6.3 [313-317 KINGS WAY, SOUTH MELBOURNE - PDPL/01035/2021](#)

LOCATION/ADDRESS: 313-317 KINGS WAY, SOUTH MELBOURNE

1. PURPOSE

1.1 To provide Council's position for an upcoming Victorian Civil and Administrative Tribunal (VCAT) compulsory conference and hearing for planning permit PDPL/01035/2021 for:

Proposed north elevation outlining the overall height and scale

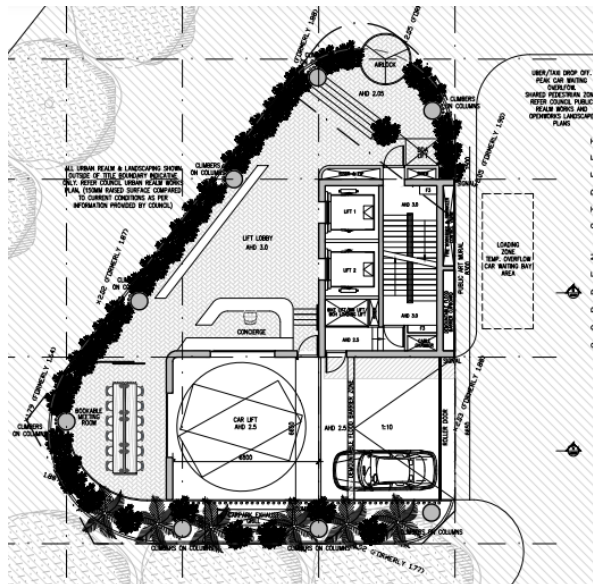
- 2.7 Whilst the site is strategically located for an office development, concerns are raised with a number of aspects of the proposal including;
 - The protrusions into the landscape setbacks at the ground and upper level would not meet the precinct wide and sub-precinct objectives of the DDO

- The lack of upper level setback to Kings Place and Cobden Street would not meet the precinct wide and sub-precinct objectives of the DDO.
 - The proposed height would be excessive given the limited site constraints and would be an overdevelopment of the site and would not meet the precinct wide and sub-precinct objectives of the DDO.

General ground floor layout

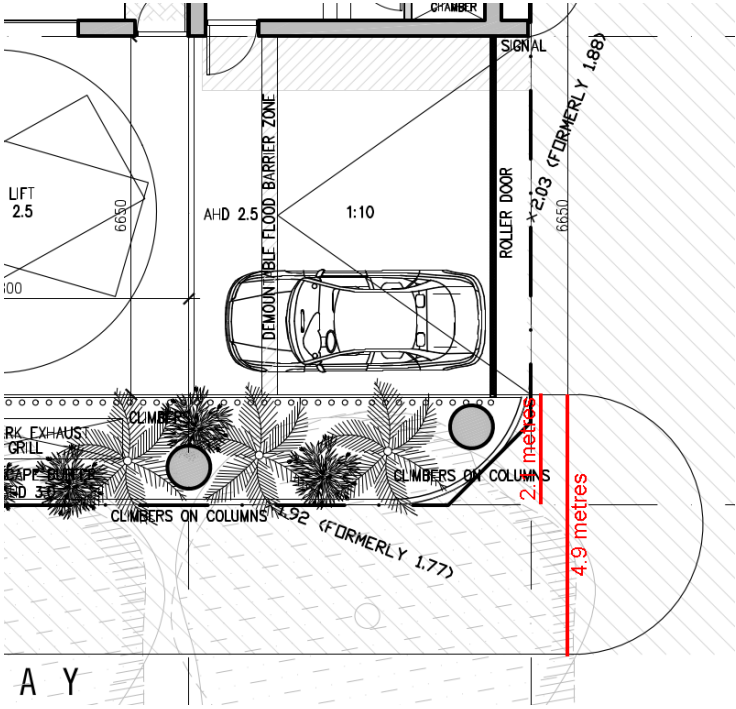
<p>A 3-metre landscape setback should be provided to the direct frontage or abuttal to Kings Way.</p>	<p>Not Achieved</p> <p>The plans show a 2-metre setback rather than the required 3 metre setback at the ground floor Kings</p>
